17 August 2018

Dean Miller
c/o Hamilton City Council
Private Bag 3010,
Hamilton, 3240

Amberfield subdivision development – Response to further information request

HAMILTON SOUTH DEVELOPMENT

Figure 1

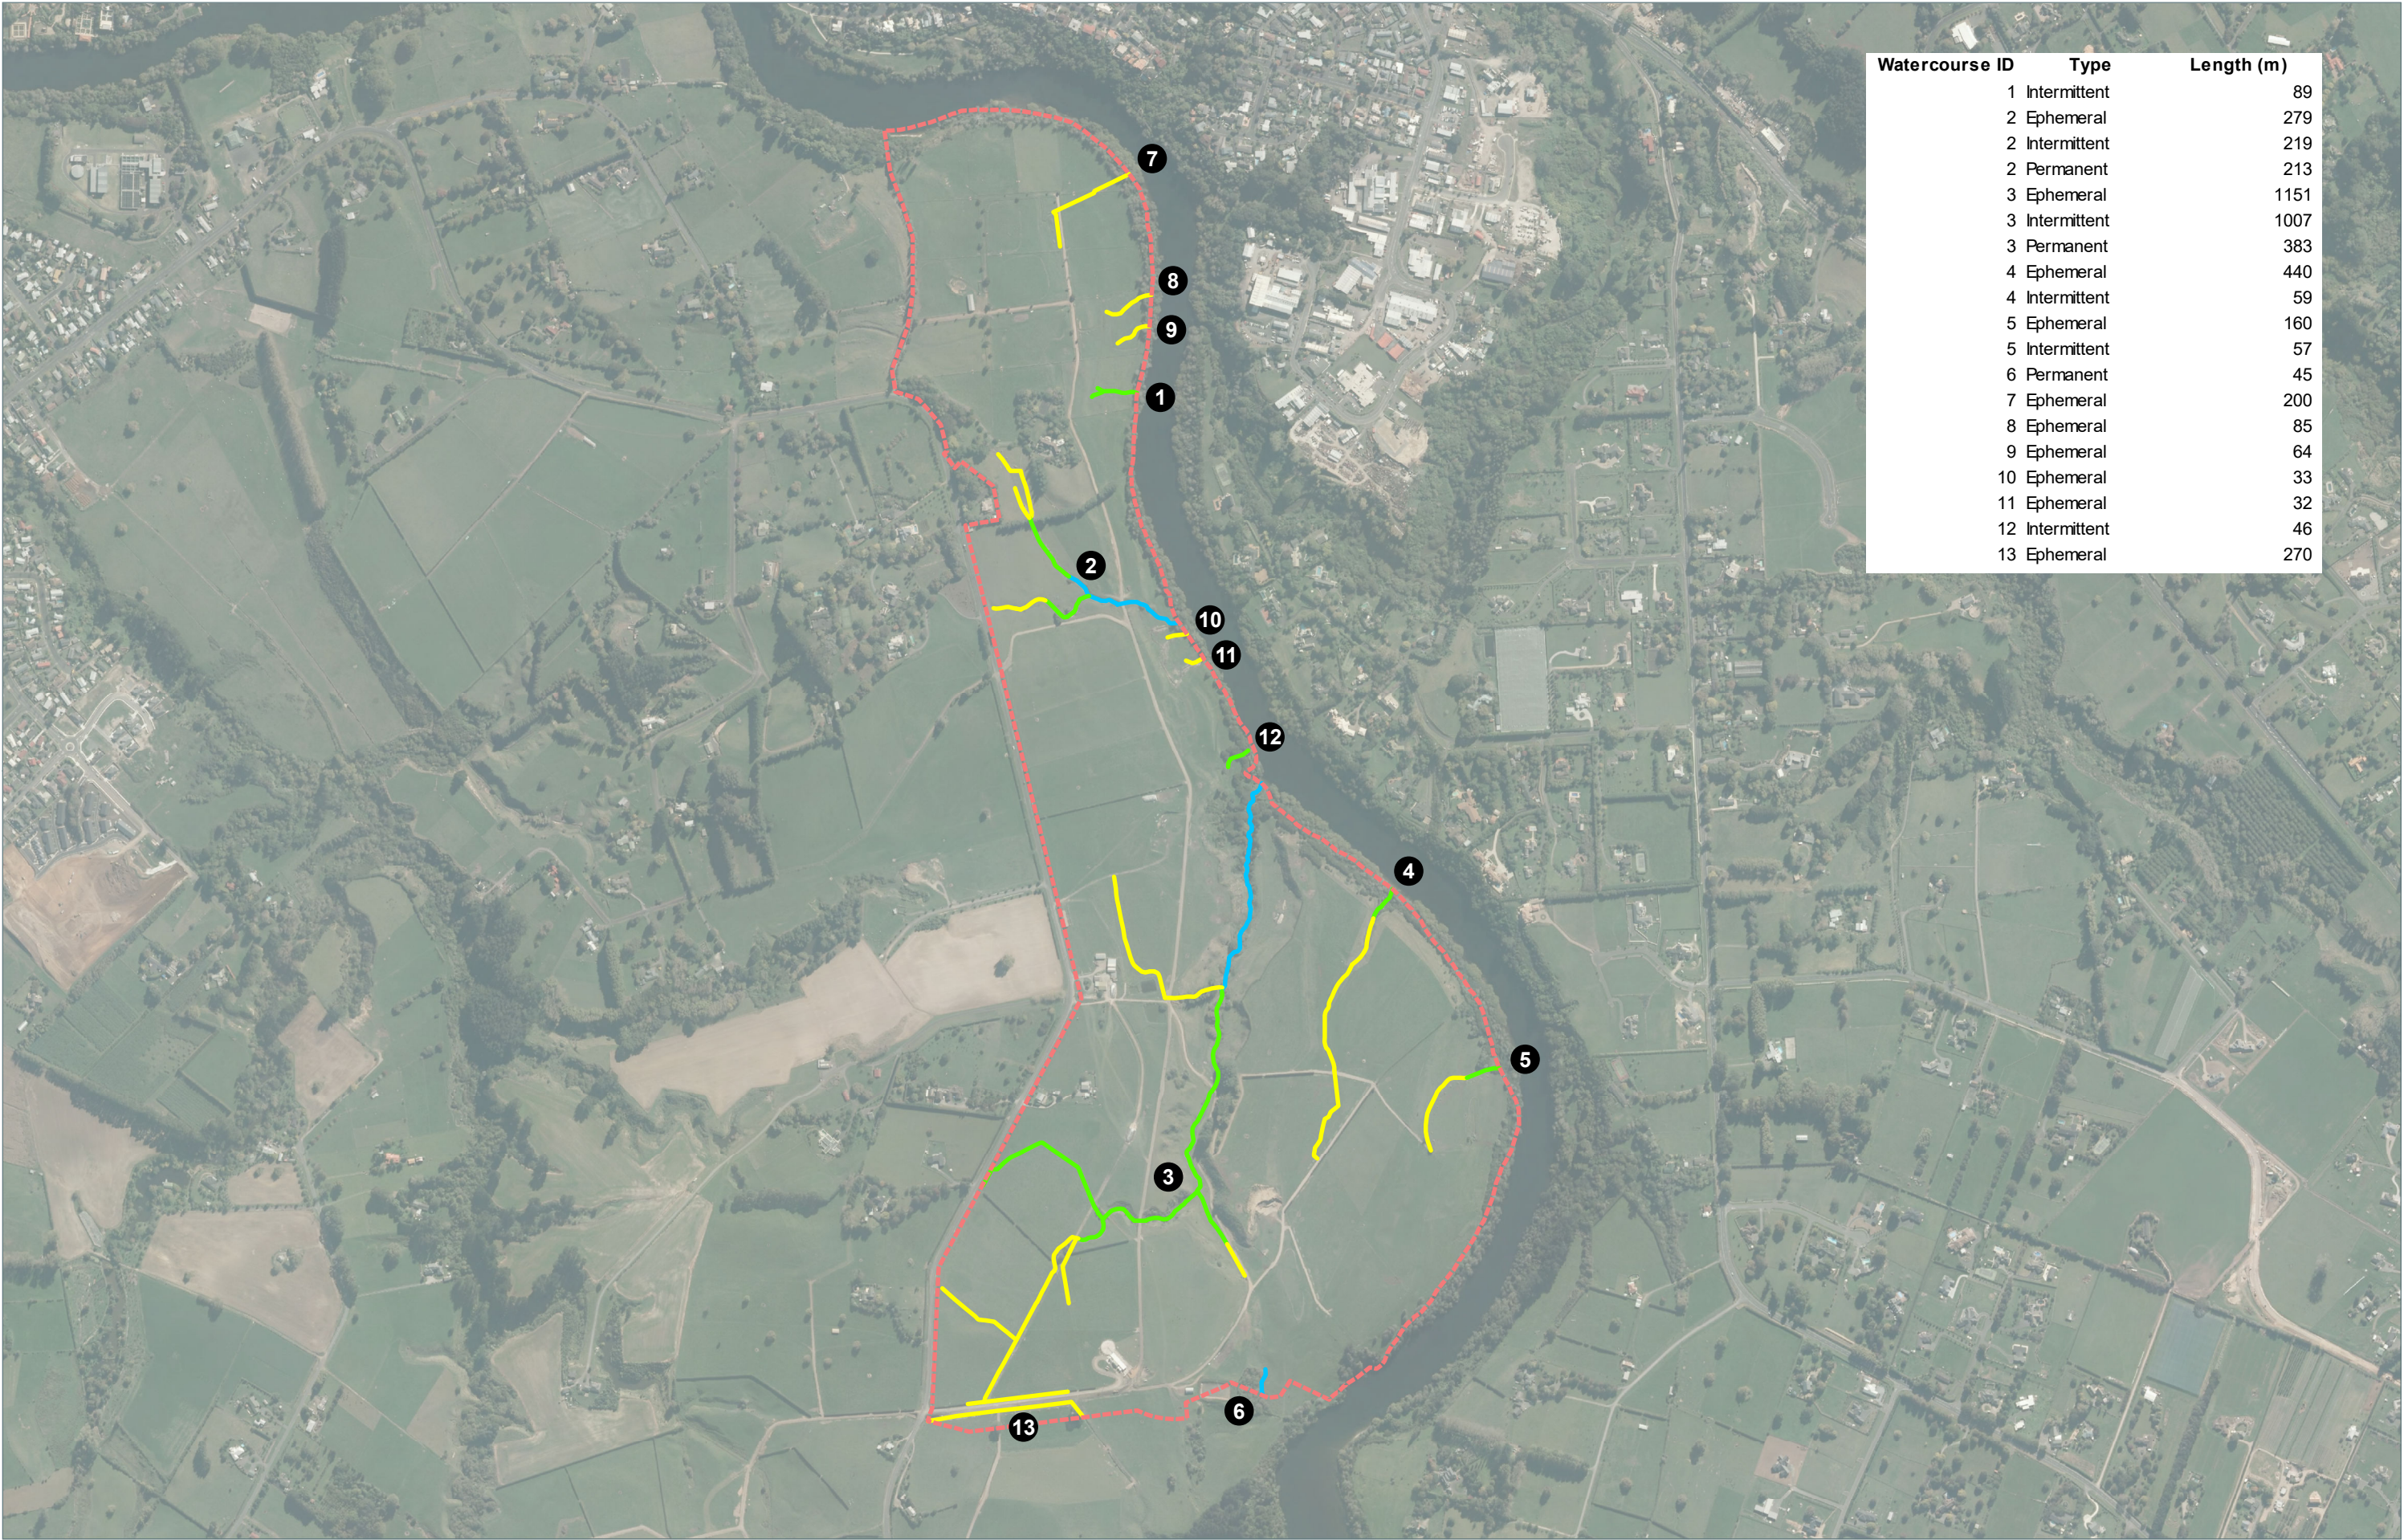
78. *There is a recognised field assessment season for intermittent streams in the Auckland Region of July to October inclusive. This is on the basis that assessments should take place when flowing water is present in the stream, following a minimum of two months of winter flows to provide an accurate assessment of the biological values. Assessments undertaken by the applicant to date have been in November, February and April, albeit following some antecedent rainfall. Conditions during the 5*

June 2018 site visit were relatively wet and flowing parts of site streams more extensive than outlined in the ecology reports. Please provide discussion on the impact that site investigation timing may have had on the observed extent of intermittent sections of stream and the potential that biological values have been underestimated as a result of survey timing. Please advise if it is proposed to re-visit the site during the July to October period to confirm the extent of intermittent stream or how the mitigation is precautionary in terms of addressing this uncertainty. This has potential implications for the quantum of mitigation needed to address stream loss.

84. *In light of conditions observed on the 5 June 2018 site visit are any of the “additional watercourses” referred to in Section 3.1.7 of the BML report likely to be more intermittent in nature than seepage as described. Some of the watercourses in the northern part of the site had formed channels and were flowing and therefore may be intermittent in nature. This is relevant in terms of the cumulative effect of seepage and intermittent stream habitats as a result of the proposed development (Policy 21.2.1b of the DP). Please confirm if it is appropriate to exclude the “additional watercourses” from the effects assessment in light of channel and flow conditions observed on the 5 June 2018 site visit and any reasoning, including specific reference to potential conditions anticipated to occur between July to October.*

In addition to the above, a second site visit was completed on 24 July 2018 to assess intermittent and ephemeral stream flows based on the AUP OP definitions. Approximately 3mm¹ of rainfall fell in the preceding 48 hours. An updated figure of stream classifications (updated from Figure 1 of the BML Freshwater Ecology Report (Appendix H)) for the site is provided in Appendix 1 (Figure 1). Please note the changes include:

- The addition of six ephemeral waterways (numbered 7 to 11 and 13),
- The addition of an intermittent waterway (numbered 12),
- A change of ephemeral waterway to intermittent along watercourse 2,
- The extension of ephemeral waterway at the upstream end of watercourse 3 that flows towards the south and out of the proposed development site. (Note that discretion was used when assessing the classification of this waterway due to recent activity (removal of instream vegetation and material damming waterflow), and
- The extension of ephemeral waterway along watercourse 4.

As discussed in point 78, a second site visit was completed on 24 July 2018 to assess intermittent and ephemeral stream flows based on the AUP OP definitions. An updated figure has been provided in Appendix 1 (Figure 1) while the values of these waterways have been provided for under point 85 below.

Figure 3

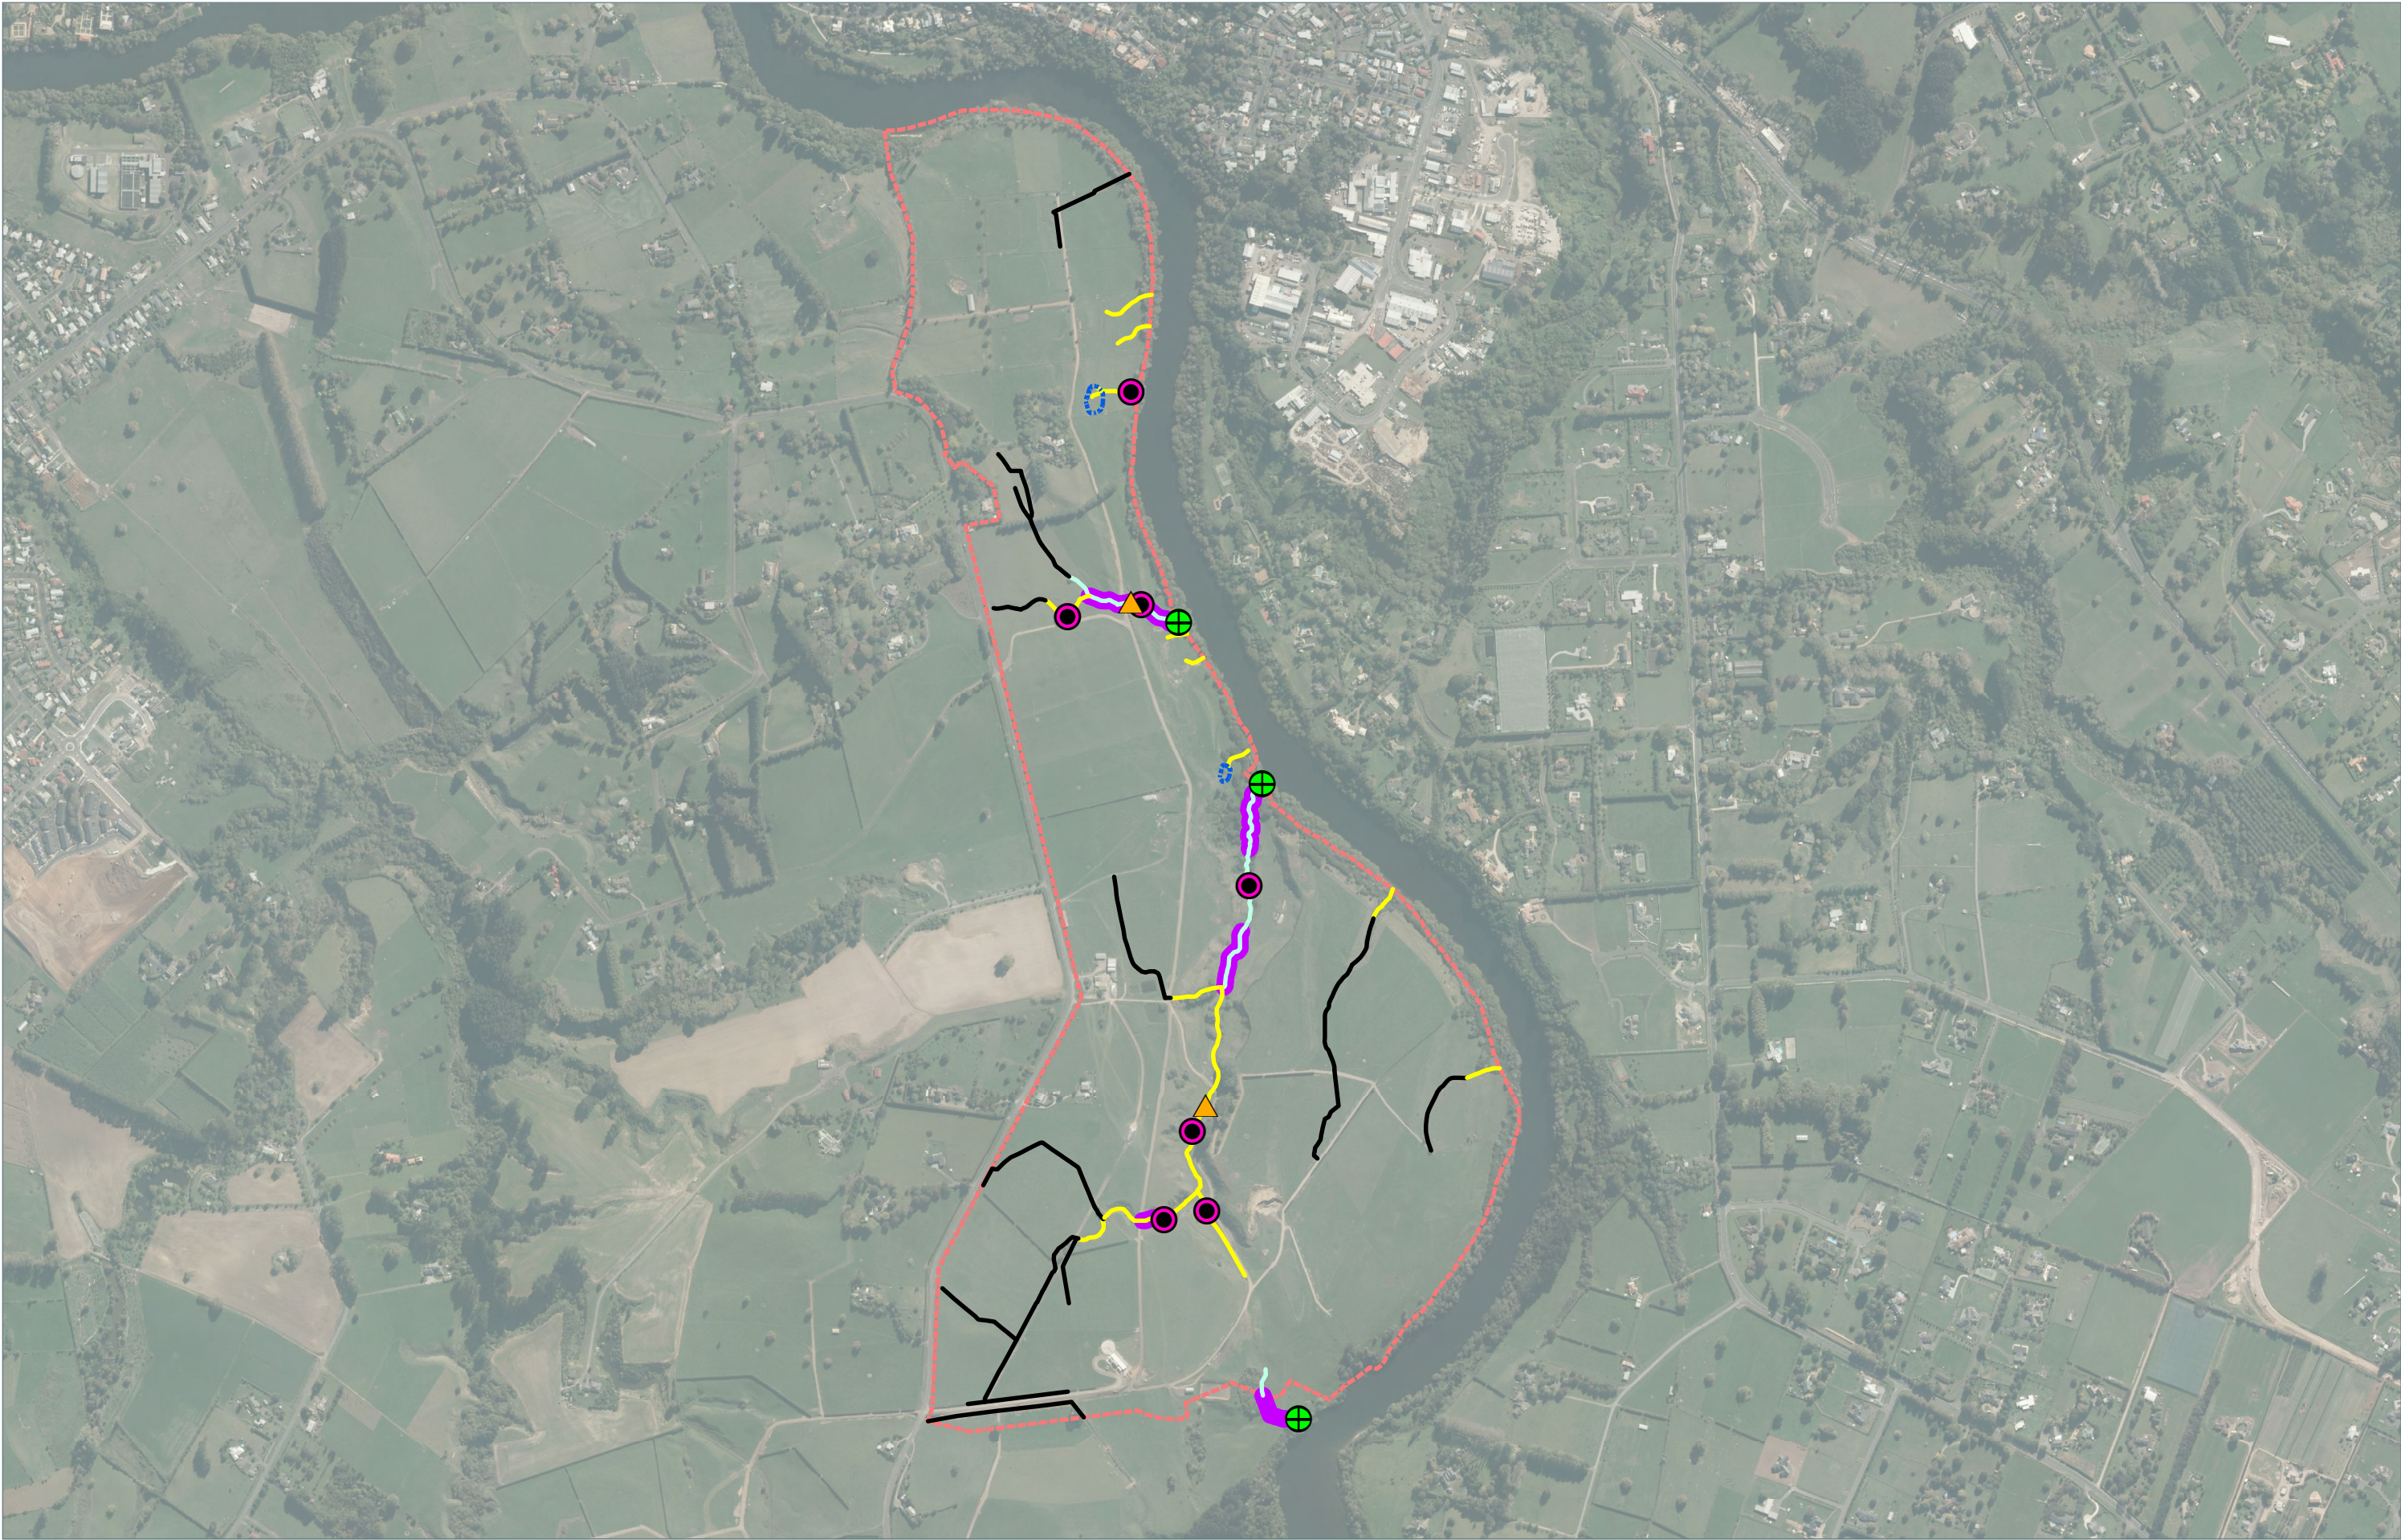
77. *The stream classification in the Argo Environmental Ltd (AEL) and Boffa Miskell Ltd (BML) Freshwater Ecological Assessments have used the ephemeral, intermittent and permanent stream definitions from the Auckland Unitary Plan Operative in Part (AUP OP). AUP OP definitions have been used in favour of the definitions in the Waikato Regional Plan (WRP) on the basis that the WRP does not include a definition for intermittent streams. Mapping provided and using AUP OP classifications provides different information compared to that preferred by HCC as set out in the ICMP REM which uses WRP definitions and includes mapping the boundaries of wetlands including stream associated wetland habitats. This is also an information requirement in Table 1.2.2.6b in Appendix 1 of the HCC District Plan. Please provide a map and supporting GIS data showing stream classifications using WRP definitions and including the extent and boundaries of any wetlands, including stream associated wetland areas.*

A map has been provided (Figure 3, Appendix 1) classifying streams using the WRP definitions for farm drainage canal, ephemeral stream and perennial stream. In addition, as requested during our phone conversation on 26 July 2018, macroinvertebrate and water quality sample locations as well as fish assessment reach have been included. Note that the sample locations are indicative only and have not been marked on the map using location co-ordinates.

Figure 3 (Appendix 1) provides the location of two seepages. These seepages are heavily degraded due to stock pugging and grazing and are likely to be lost/ modified as part of the development. Several seepages (not mapped) are present within the gully systems (there are likely to be more that were not observed) in watercourse two and three and which will be protected and enhanced as part of the gully planting and restoration.
